RE: Preliminary Plan No. 120170040  
Sketch Plan No. 320170050  
8600 Georgia Avenue

Thank you for the opportunity to review the Preliminary Plan 120170040 submittal for the proposed **8600 Georgia Avenue** development – **16APMO033XX** located on **MD 384** (mile point: 0.53) in **Montgomery County**. The State Highway Administration (SHA) has reviewed the plans and is pleased to respond.

Re: 8600 Georgia Avenue  
Performance Based Design Review  
Preliminary Plan #120170040

**FIRE DEPARTMENT ACCESS PLAN**

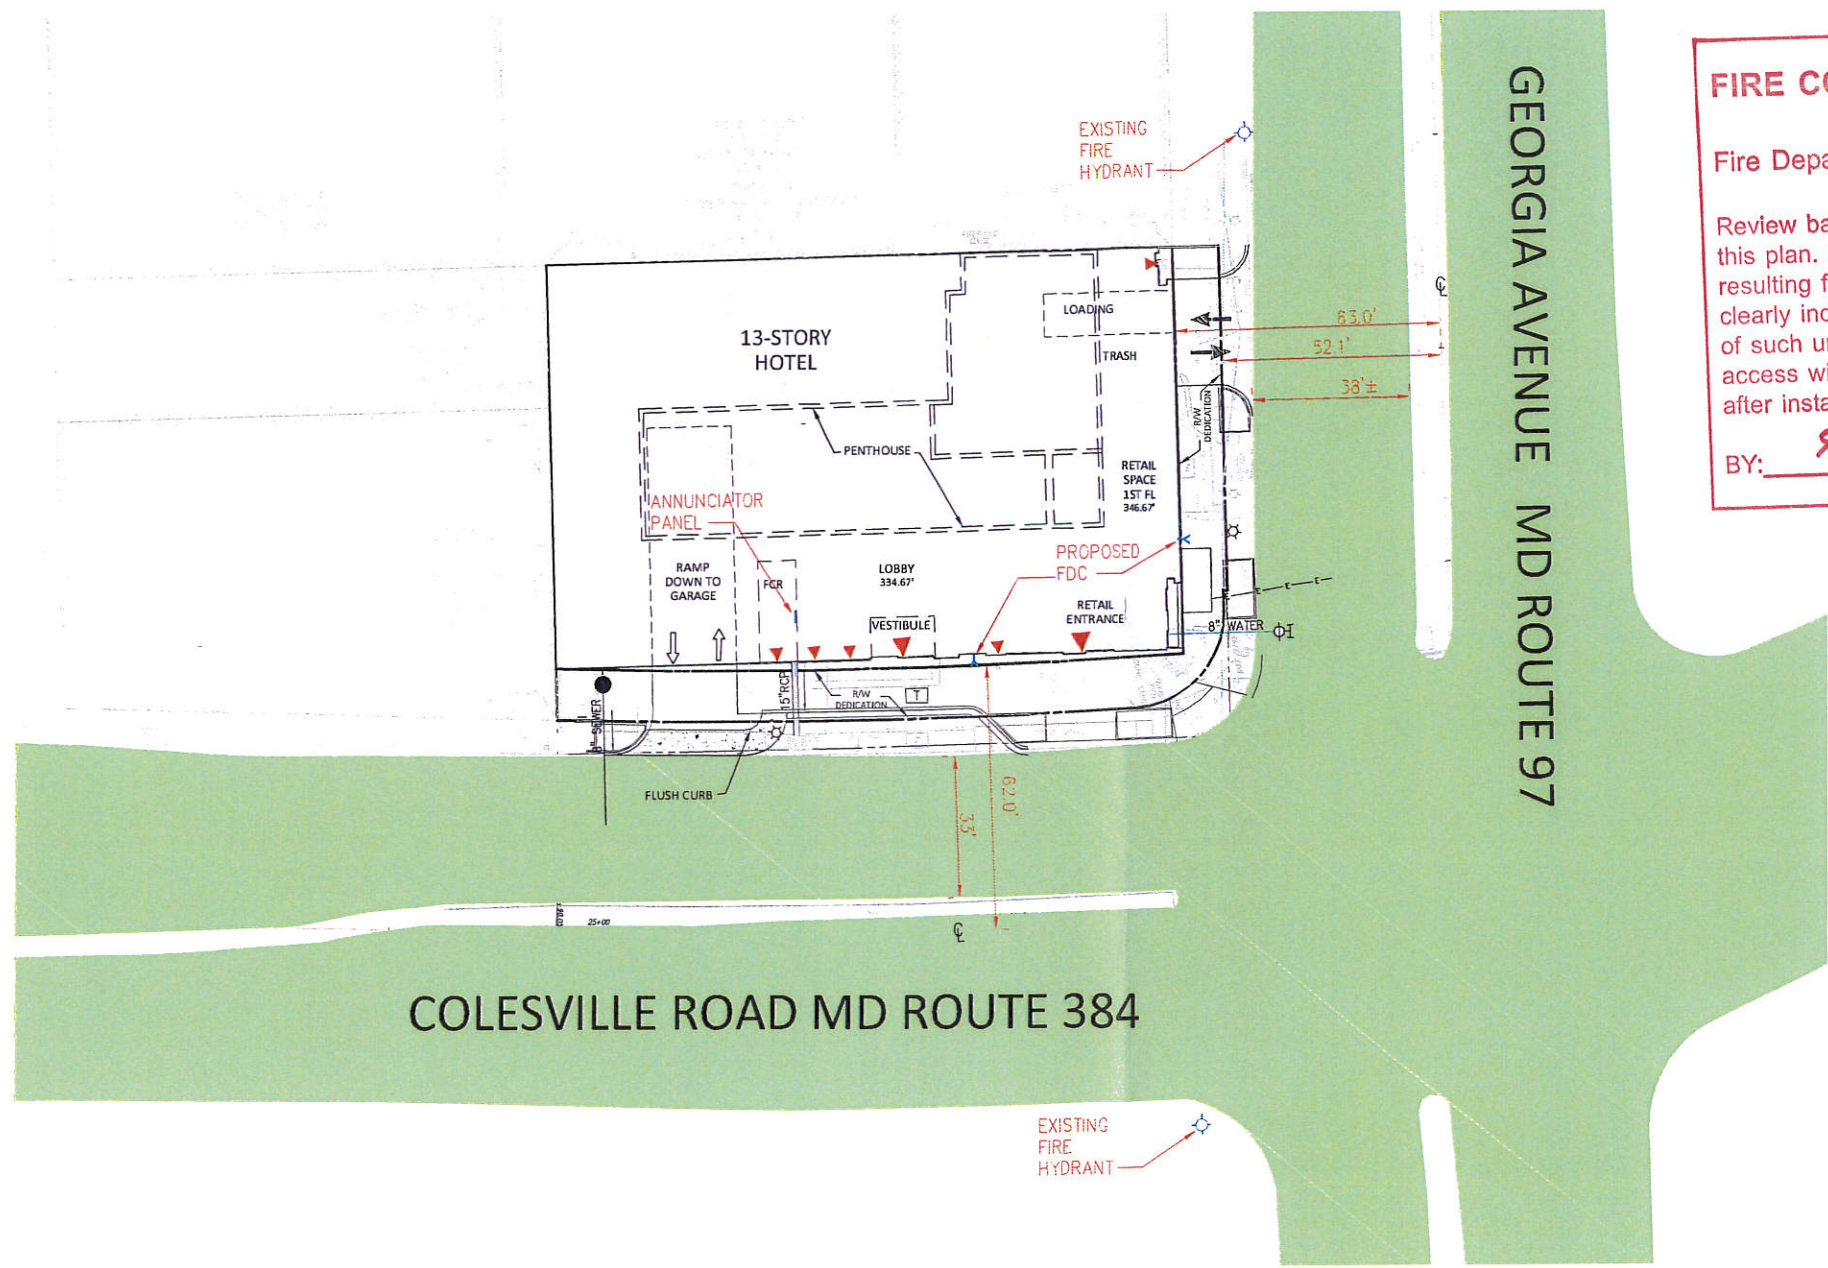
As shown on the attached Fire Department Apparatus Access Plan, a minimum 15' free and clear pathway will be maintained along the frontage of the property with Georgia Avenue and Colesville Road. However, because the building will be situated on the property line (along the rear and side property lines) immediately abutting neighboring buildings to the north and west, no free and clear pathway is possible. For this reason, there will be no windows along these property lines.

In consideration of the architectural design with no setback along the two property lines, but with free and clear access provided along the entire frontage with the adjacent roadways, which also serve as the fire access lanes, we believe that the performance based design in this case will ensure that access for fire apparatus will be adequate.

**PLAN APPROVED**
